MCPB ITEM NO. **I** 10-30-2003

MEMORANDUM

Greencastle Road

Mandatory Referral No. MR No. 03812-DPW&T-1

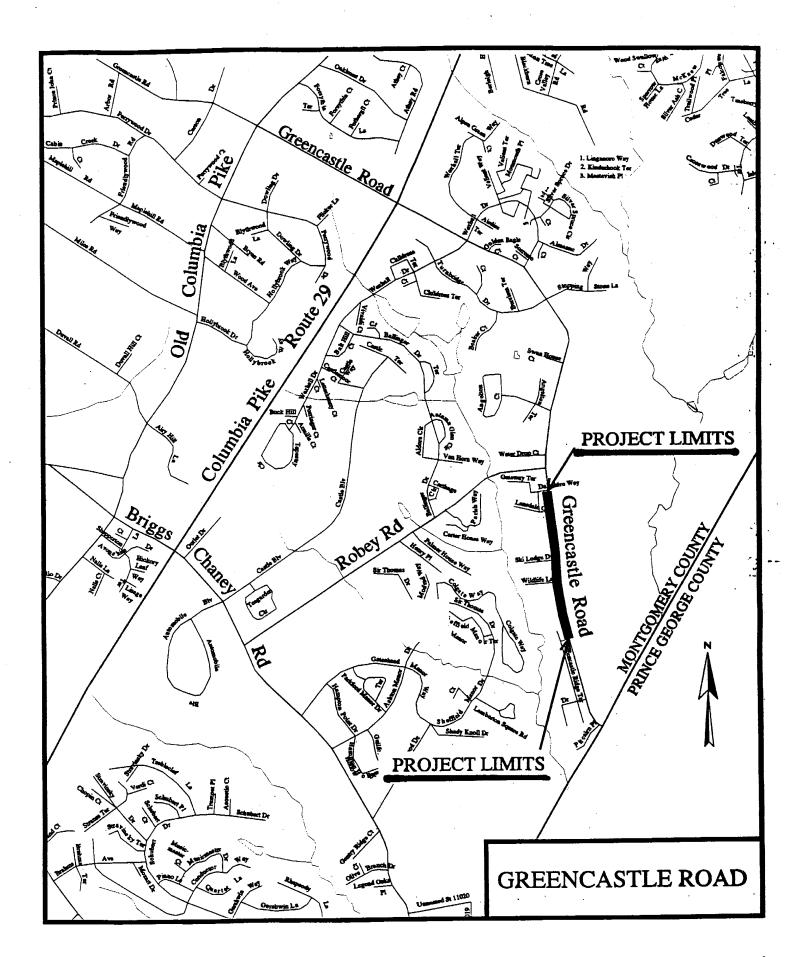
1. Construct a median with a pedestrian refuge at the intersection of the Fairland Recreational Park entrance and Wildlife Lane. Stripe the crosswalk and provide advance warning signage at the intersection.

- 5. Construct a lead sidewalk from the Wildlife Lane intersection to the nearest parking lot driveway in the park.
- 6. Provide a two-foot to six-foot offset from the curb to the proposed trail on the northwest corner of the Wildlife Lane intersection.
